Sent: 19/12/2023 8:55:32 PM
Subject: Submission re DA: Mod2023/0545 189 Riverview Road, Avalon Beach
Attachments: Submission - Lenthall s4.55.pdf;

SUBJECT: Mod2023/0545, Section 4.55 variation for 189 Riverview Road AVALON BEACH

Figure 1: Enlarged & Higher Rooftop Deck impacts

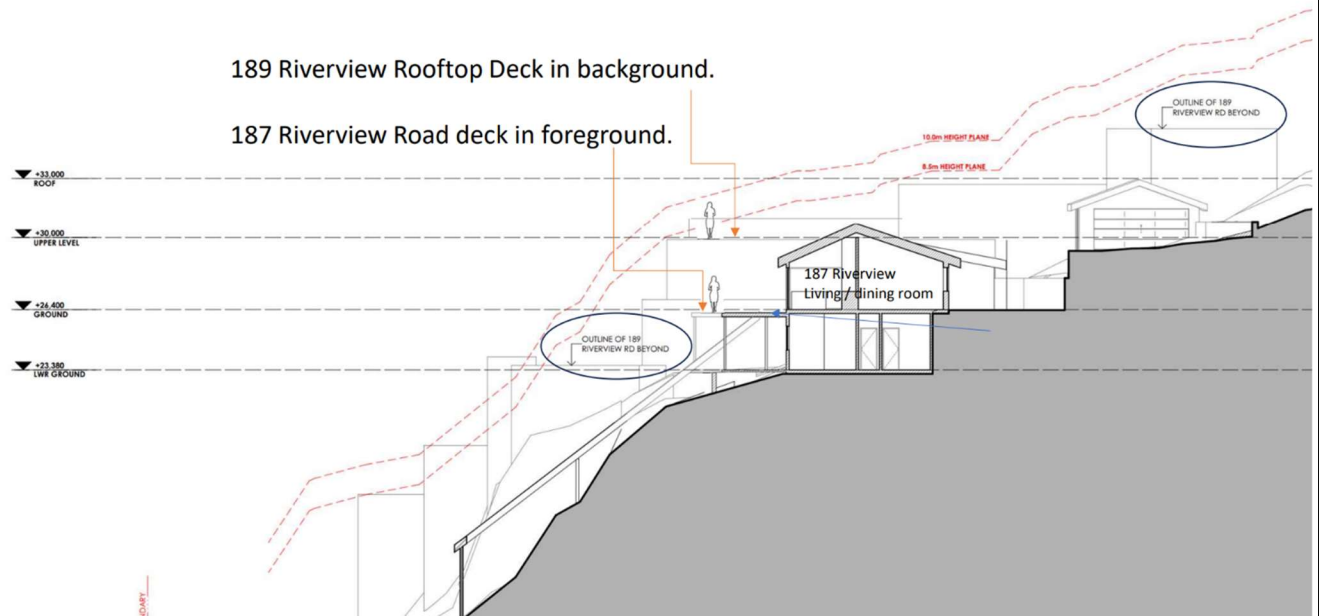
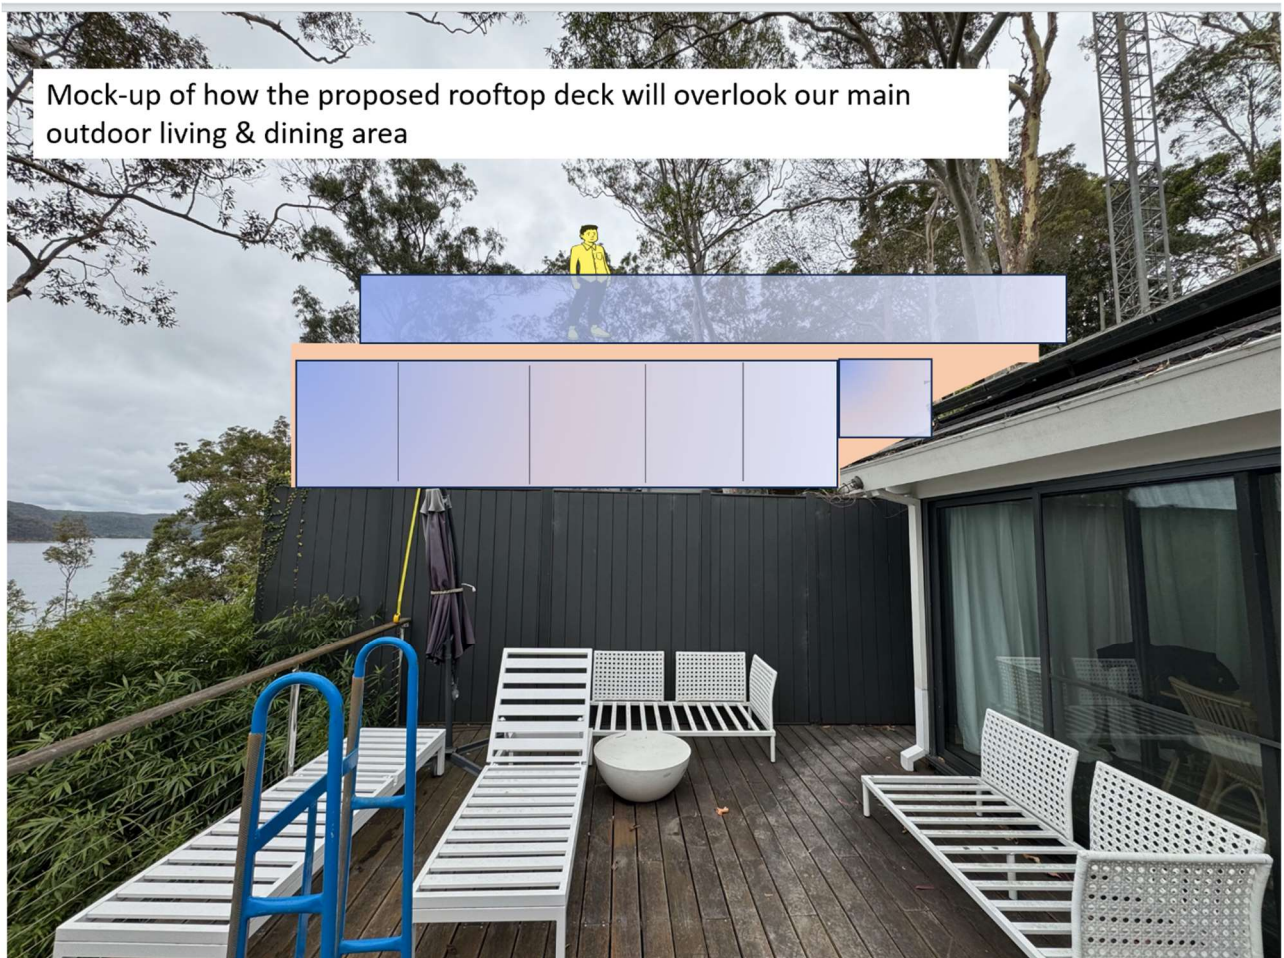
- a. Screening along the entire southern side of the trafficable section of the roof top terrace to 1.8m high, not just along the small section proposed.

Architectural drawing showing how the proposed rooftop deck overlooks our main outdoor living area & into our living room window

Mock-up of how the proposed rooftop deck will overlook our main outdoor living & dining area

Figure 2: Rooftop Deck & other balconies/terraces Visual Privacy Impacts

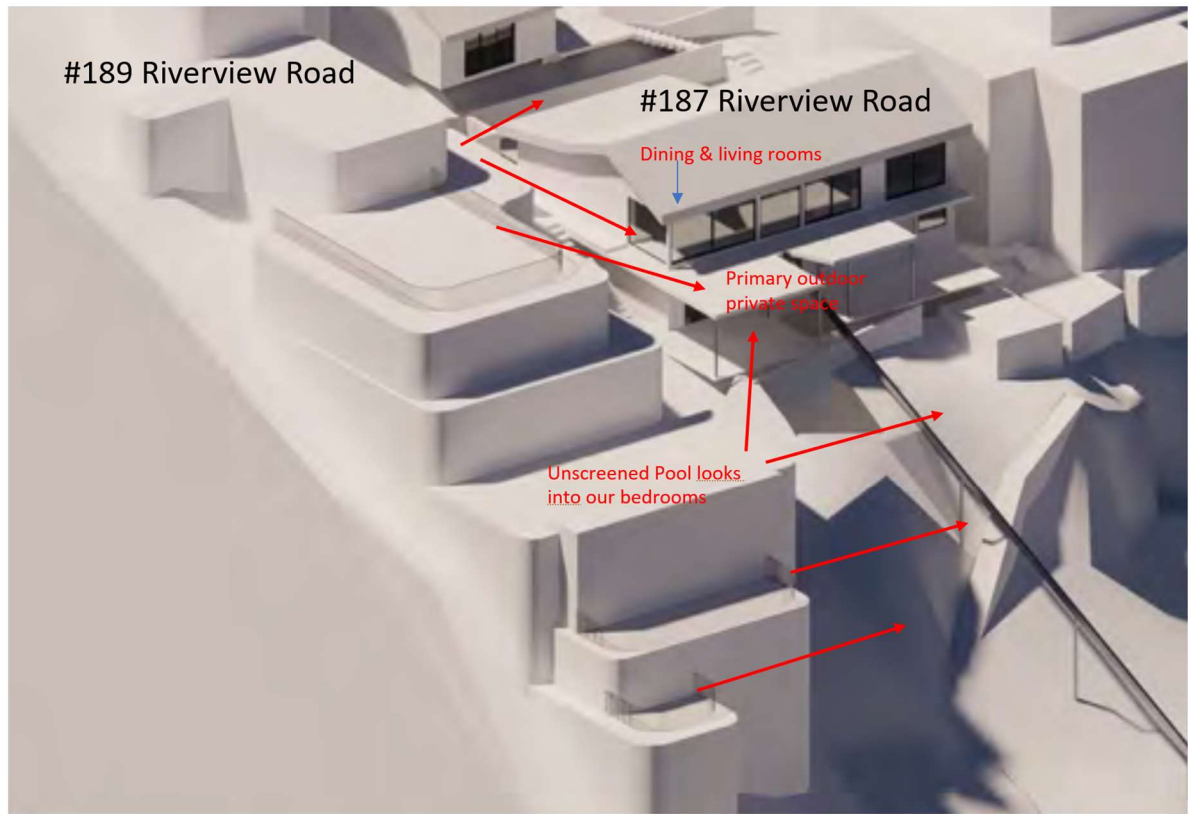
- b. Screening on the southern side of the bedroom terraces at 19.6FFL & 16.3FFL to 1.8m high;
 - c. Screening on the southern side windows of the Mezzanine level at 26.6FFL, as this level also overlooks us. The west facing study/studio windows on this level also look into our main balcony and living room and we request privacy screens on these windows.

Proposed expanded and higher rooftop deck overlooks our main outdoor living area, dining / living room and rear courtyard.
Elevated pool level looks into our lower ground floor bedroom windows as do other levels.

Figure 4: Screening needed to mitigate overlooking

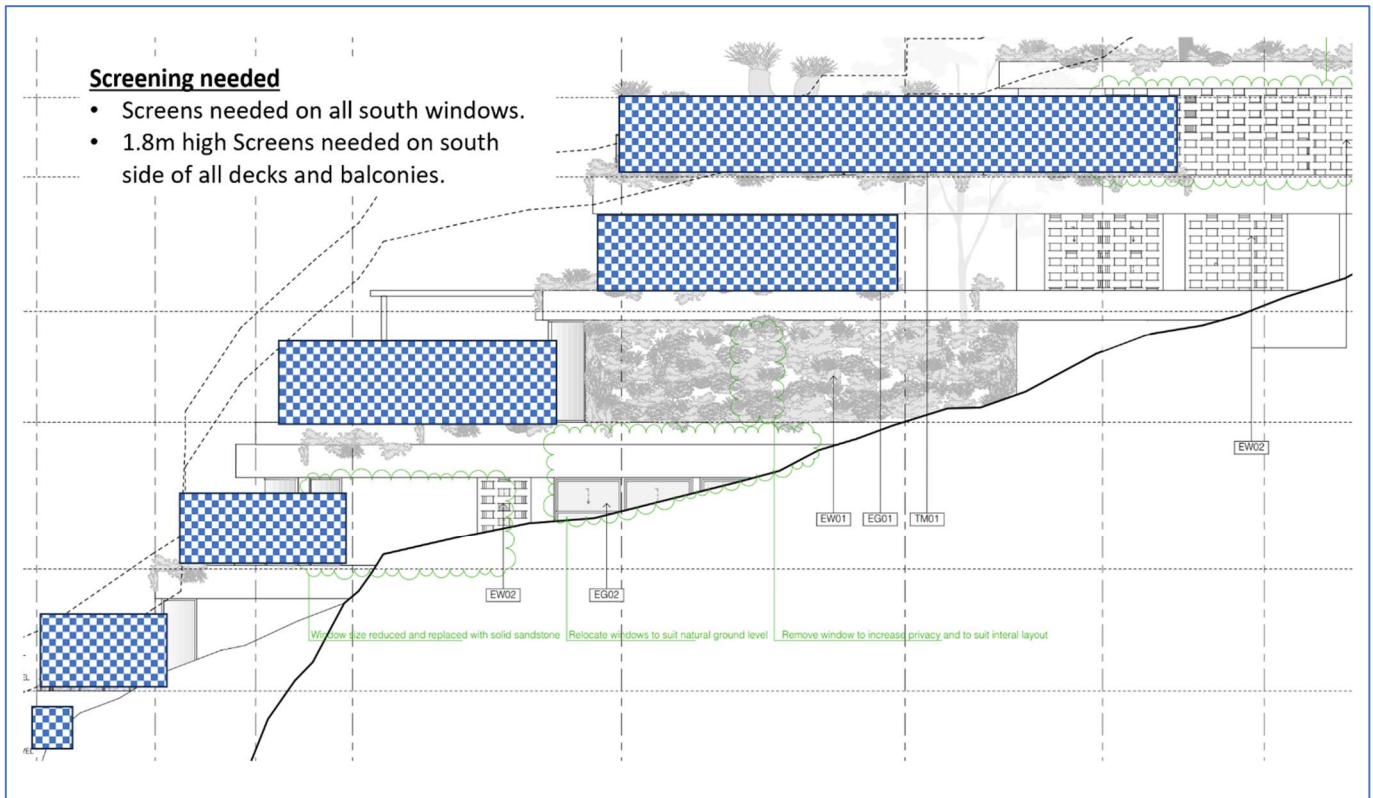
1. Fixed screening is requested on all balconies or windows on the southern side that overlook our property. Plants could die or be removed in the future, so specifically I would like to see:
